Environmental Implications of Change Report

LLK1-ARU-XXX-XXX-RP-ENV-000003

Issue 1

lionlink!

A.4 Localised changes at Lymballs Lane

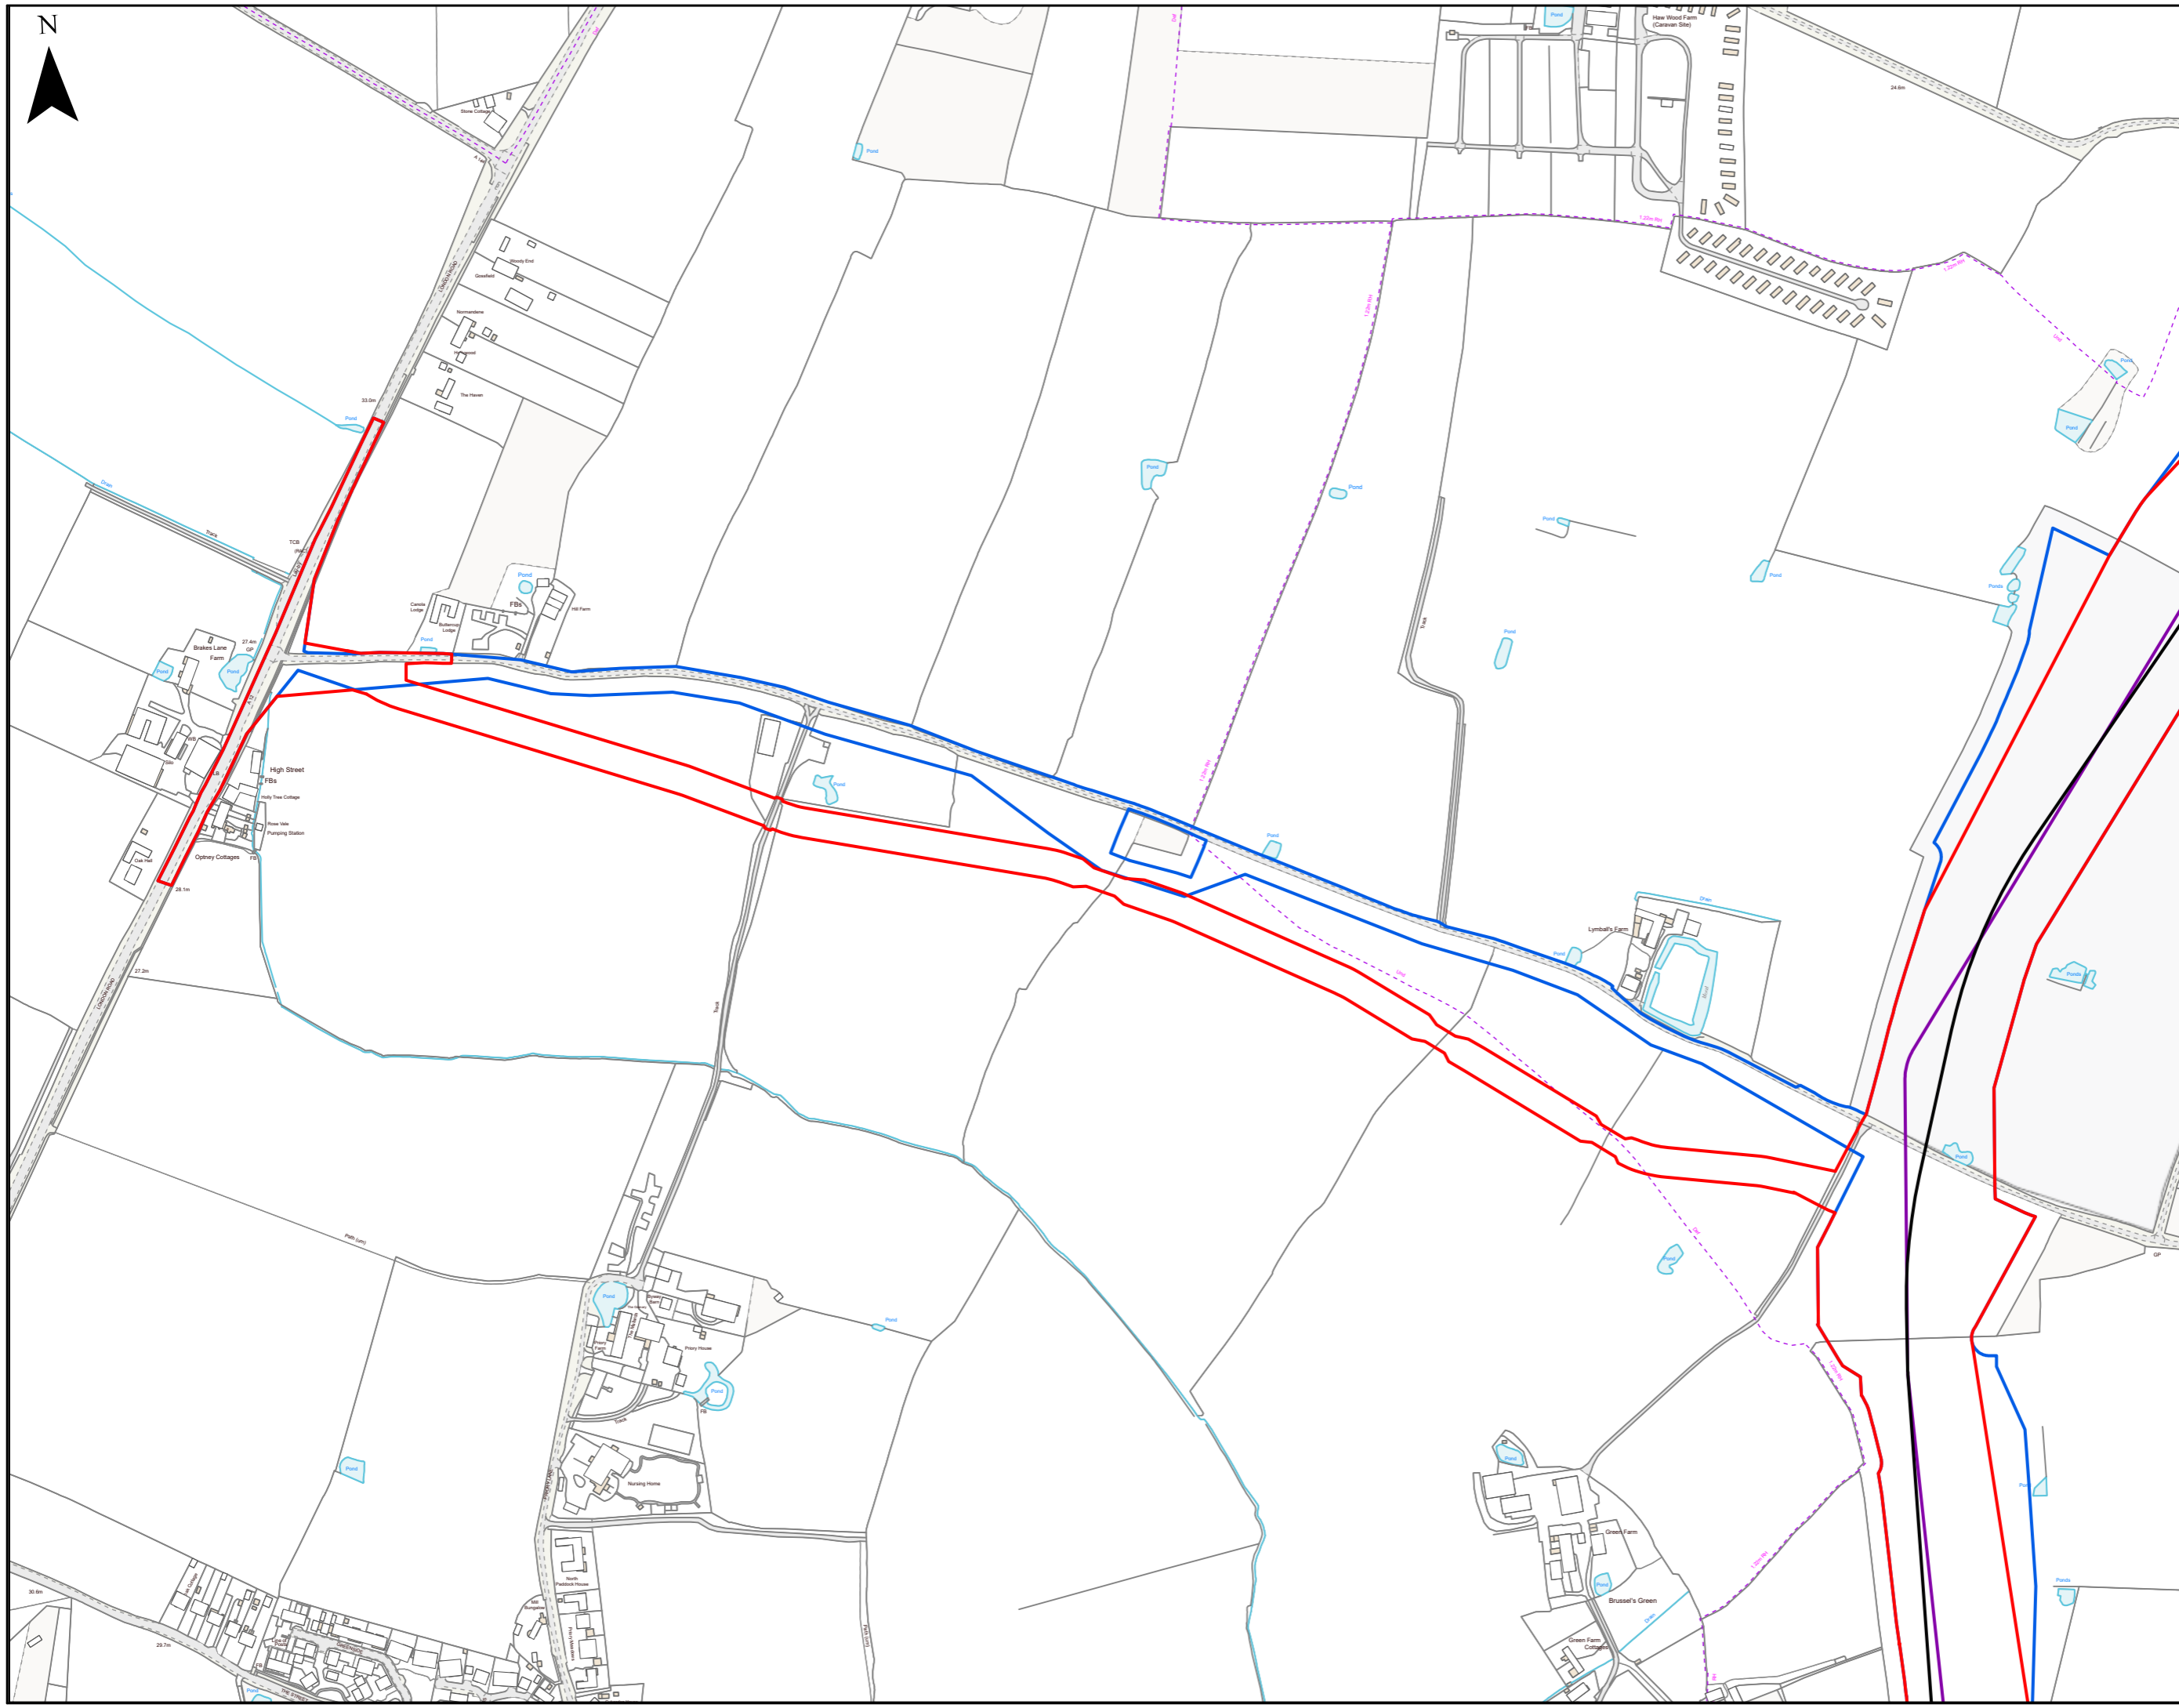
- 2.3.3 The revised approach includes a southward adjustment of the haul road alignment (approximately 50 m to 100 m), before tying into Lymballs Lane before the A12 junction. This repositioning increases separation from nearby properties, local road users and access points.
